### **TEMPORARY REVISION**

# AMM-TR-OÄM 42-204/f

# **Additional Alternator**

This Temporary Revision AMM-TR-OÄM 42-204/f is approved in conjunction with the Optional Design Change Advisory OÄM 42-204/w and is valid in conjunction with the Airplane Maintenance Manual (AMM) until this Temporary Revision has been incorporated into the AMM.

Figure 9A: Engine Shock-Mounts (if the Additional Alternator and MÄM 42-600 are installed)

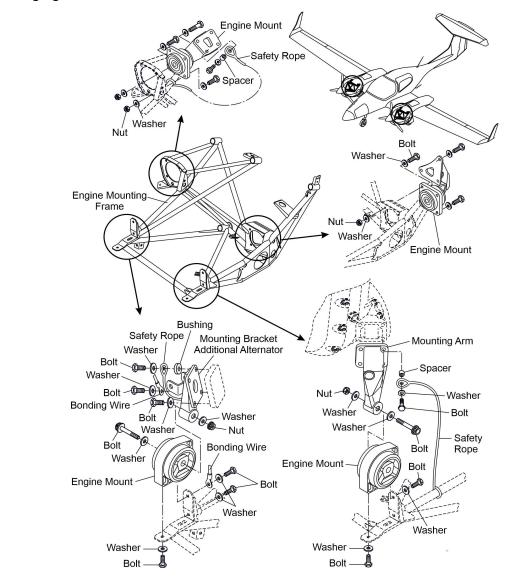
- B. Remove the Engine without Cable Harness
- The following figure is added:
